Serial No.: 09/975,840 Filed: 10/11/2001
For: Methods And Systems For Forming Embedded DRAM For An MIM Capacitor
Attorney Doc. No.: 67,200-547

MARK-UP COPY

FIG. 10

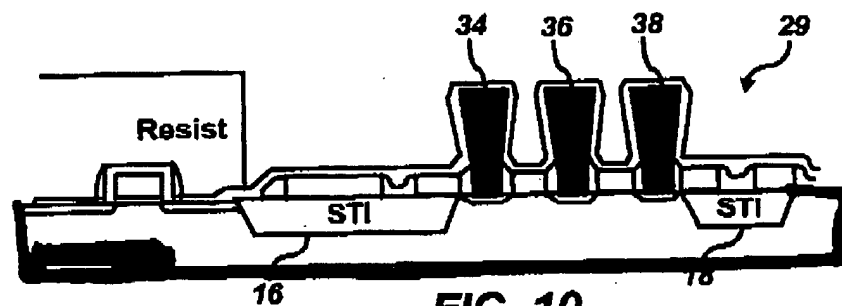
Regarding Fig. 10, the Examiner stated that space TEOS is not shown. Applicant points out that it is not necessary to show a space TEOS, because the

specification clearly points out that Fig. 10 shows the results of a TEOS wet dip. Also, TEOS is discussed thoroughly with respect to Fig. 17. The figures in their totality, including the specification and background provide sufficient enablement thereof. Applicant therefore asserts that this issue has now been removed.

FIG. 12

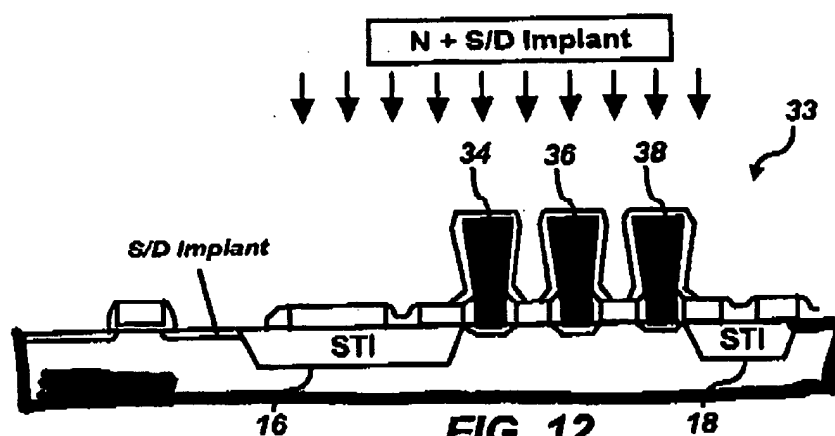
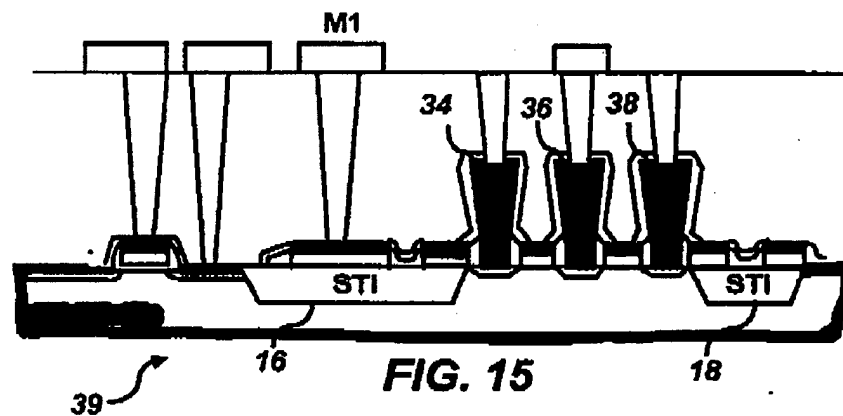
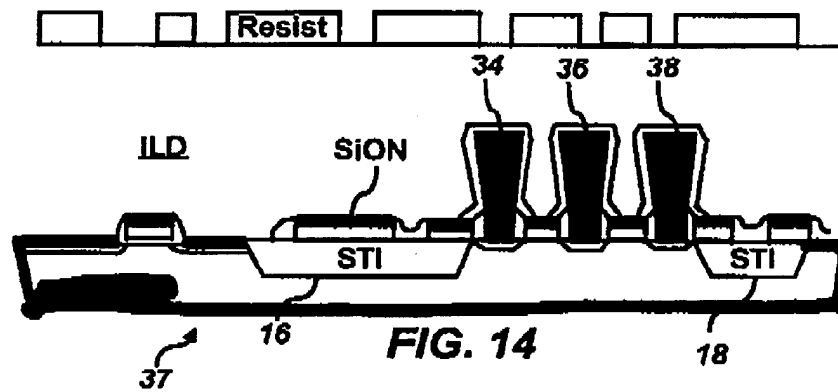
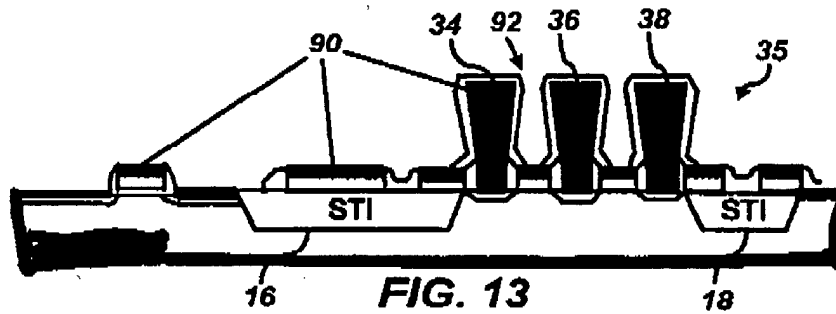
Regarding Fig. 12, the Examiner stated that it is not clear whether S/D implant is done only in the DRAM area. Applicant respectfully disagrees with this assessment. The box labeled "N+S/D Implant" is located sufficiently above the substrate and components thereof to indicate that the implant operation occurs across the entire top thereof. Applicant therefore asserts that this issue has now been removed.

**FIG. 17**

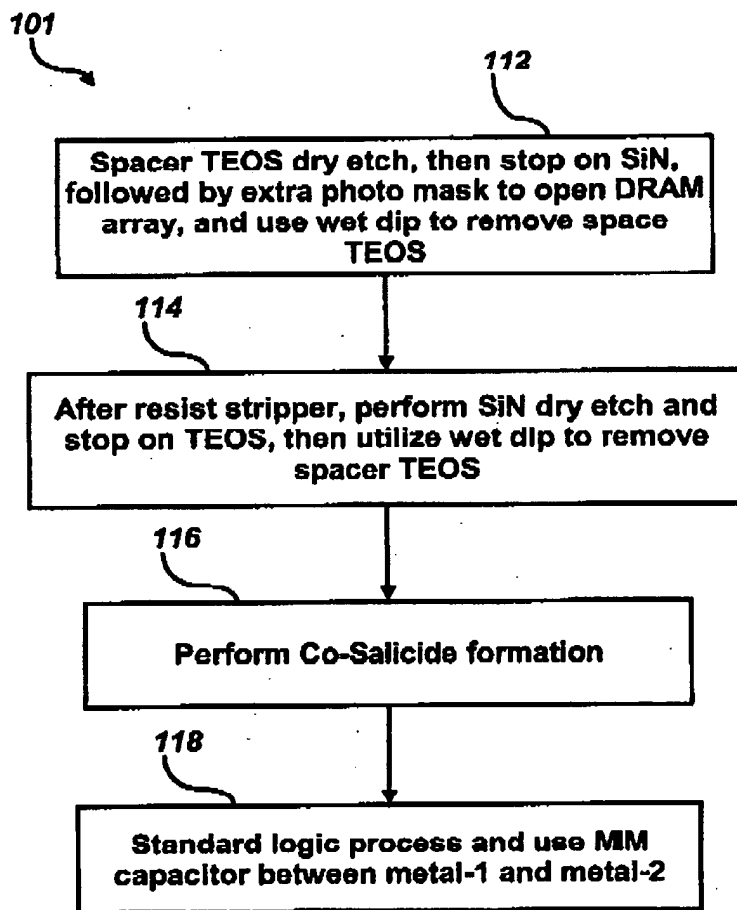
Regarding Fig. 15, the Examiner argued that the tungsten plug is not shown. Applicant has modified Fig. 15 to point out some of the plug formations. Additionally, it is not necessary to show an M2 layer because the presence of "M1" implies additional layers; otherwise if "M1" were only one layer, it would be expressed simply as "M" instead of "M1". Applicant has, however, modified Fig. 15, to show M2. Applicant therefore asserts that this issue has now been removed. Regarding Fig. 17, the Examiner stated that it is not clear what RPO means. Applicant has modified Fig. 17 to remove RPO from Fig. 17. Applicant therefore asserts that this issue has now been removed.
